MIL-F-63281A (AR)
AMENDMENT 2
28 May 1991
SUPERSEDING
AMENDMENT 1
18 May 1990

MILITARY SPECIFICATION

FUZE, ROCKET: M433 LESS BOOSTER AND BOOSTER LEAD

TABLE VI. First article test.

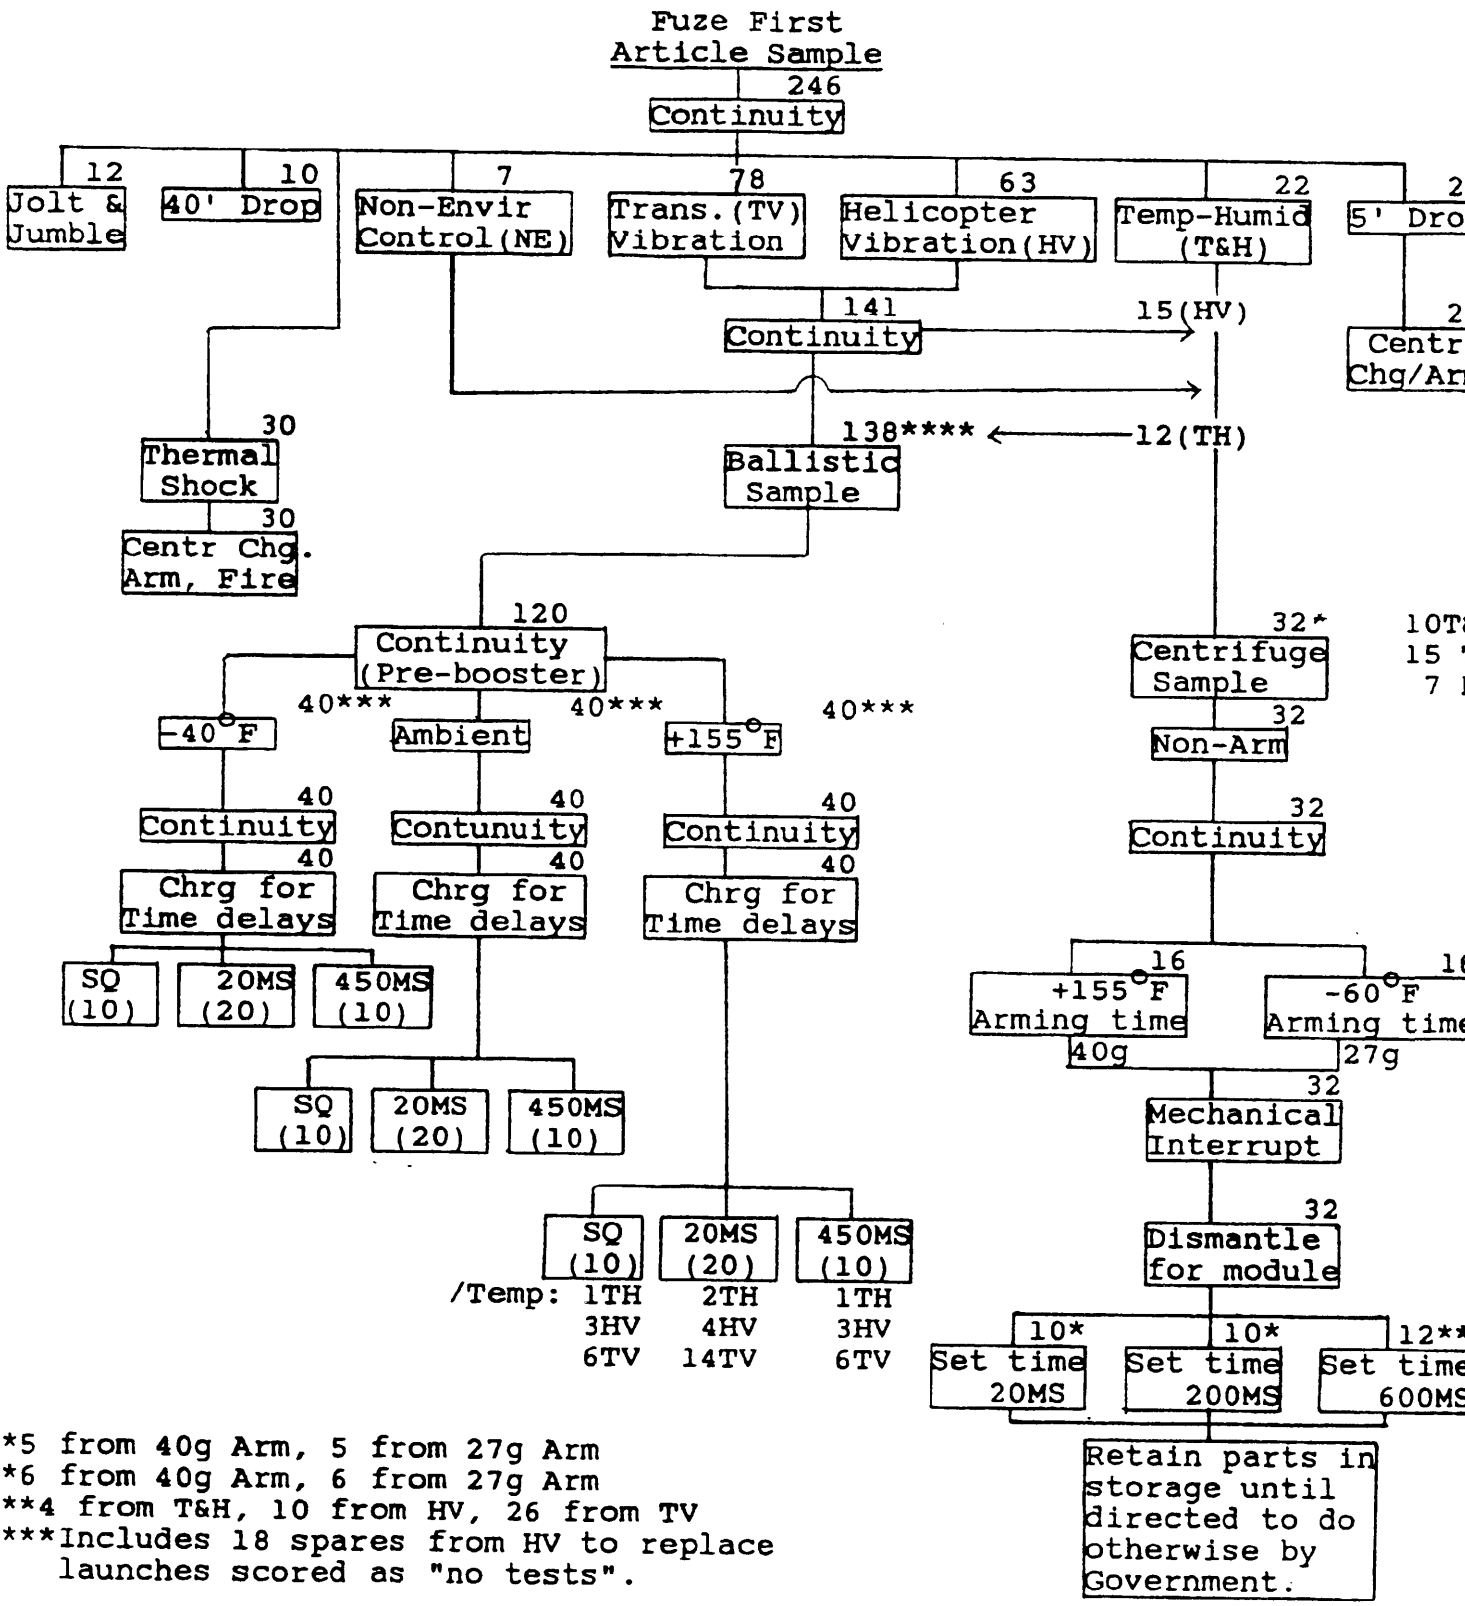
* Delete PAGE 91 in its entirety and substitute enclosed Page 10 (91).

*5 from 40g Arm, 5 from 27g Arm
**6 from 40g Arm, 6 from 27g Arm
***4 from T&H, 10 from HV, 26 from TV
****Includes 18 spares from HV to replace launches scored as "no tests".

Note: A setter that represents the helicopter setter system shall be used for delay time acceptance tests in all cases.

TABLE VII. Fuze lot acceptance test.

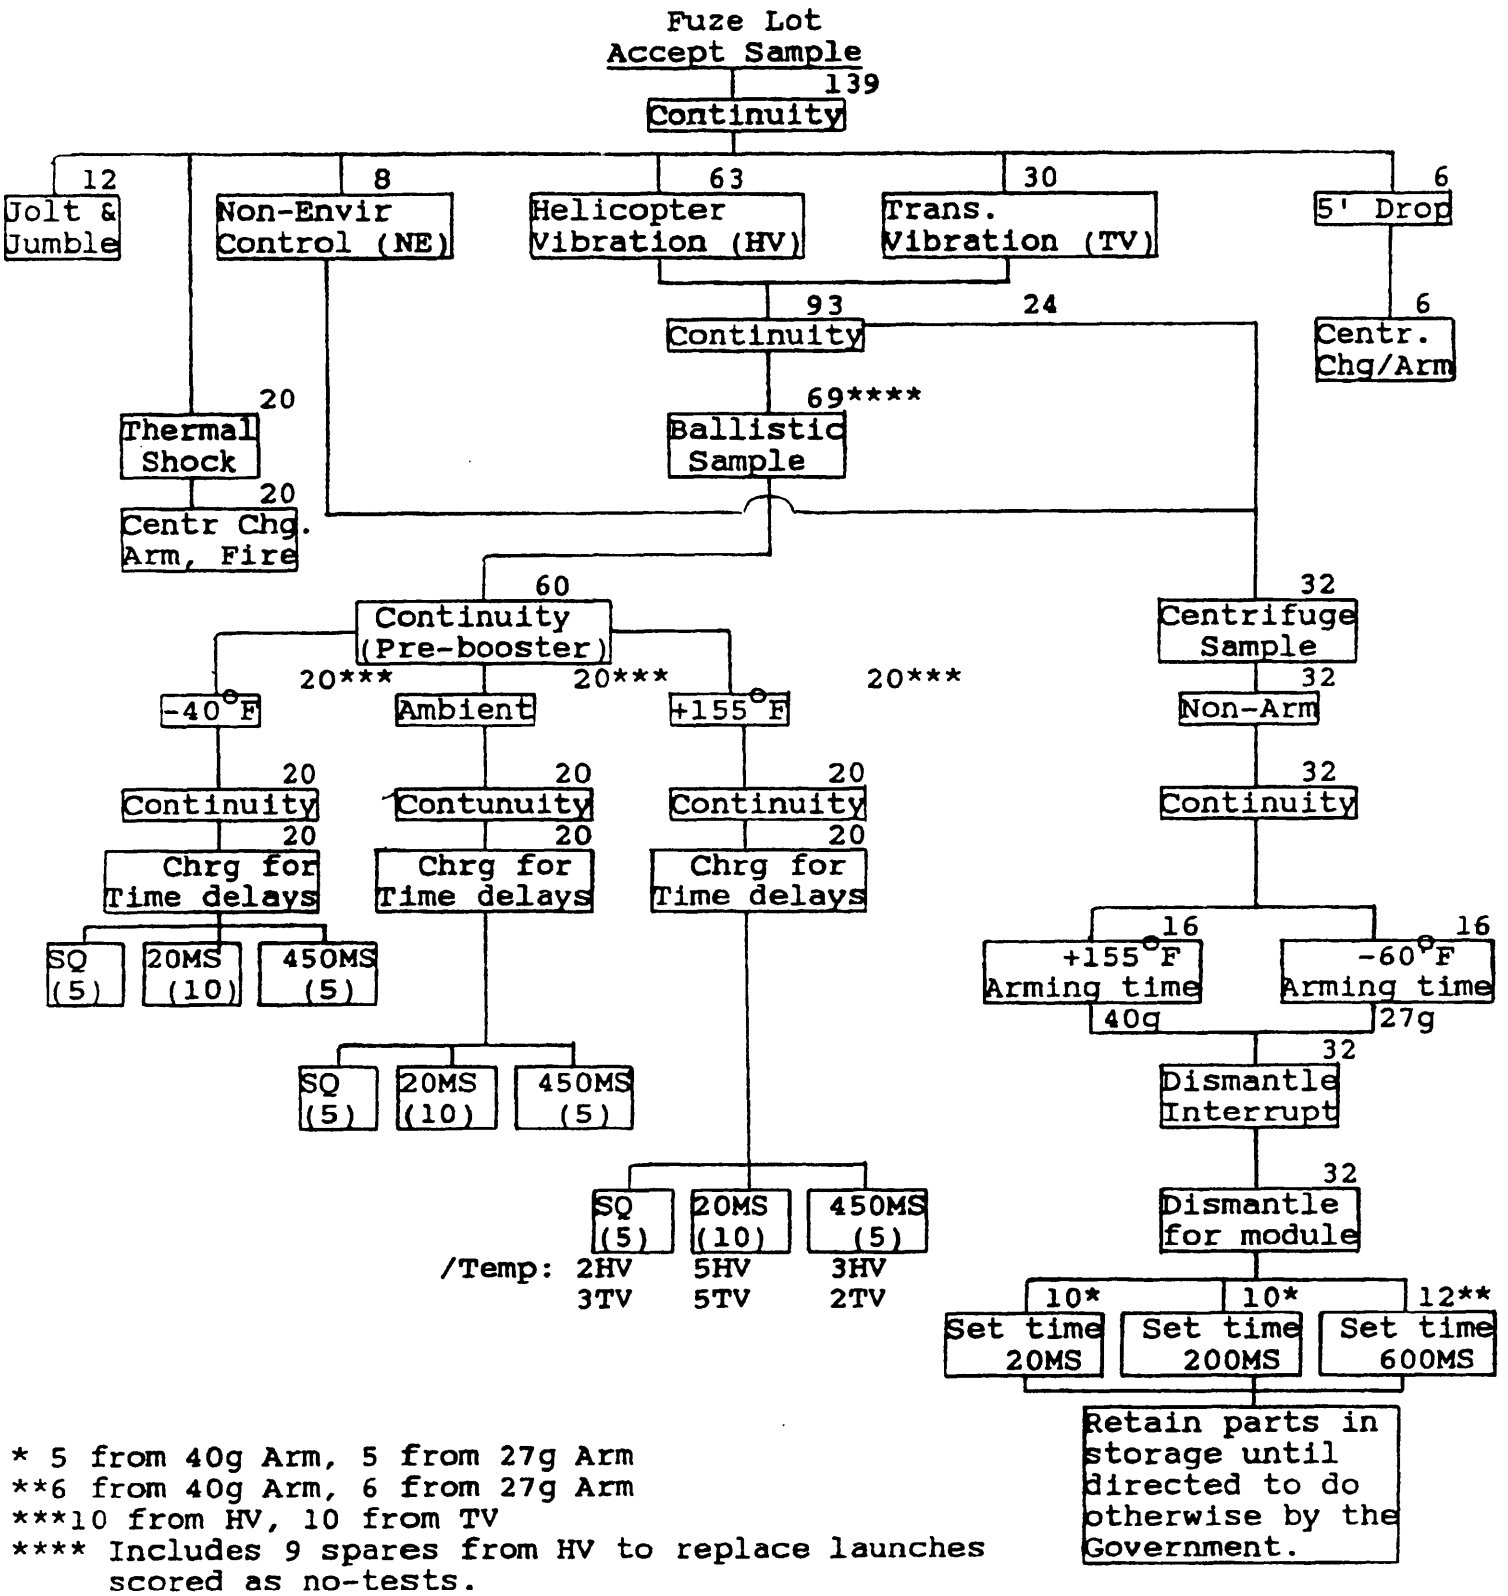
* Delete Table VII in its entirety and substitute enclosed Page 11 (94).

* 5 from 40g Arm, 5 from 27g Arm
**6 from 40g Arm, 6 from 27g Arm
***10 from HV, 10 from TV
**** Includes 9 spares from HV to replace launches scored as no-tests.

Note: A setter that represents the helicopter setter system shall be used for delay time acceptance tests in all cases.
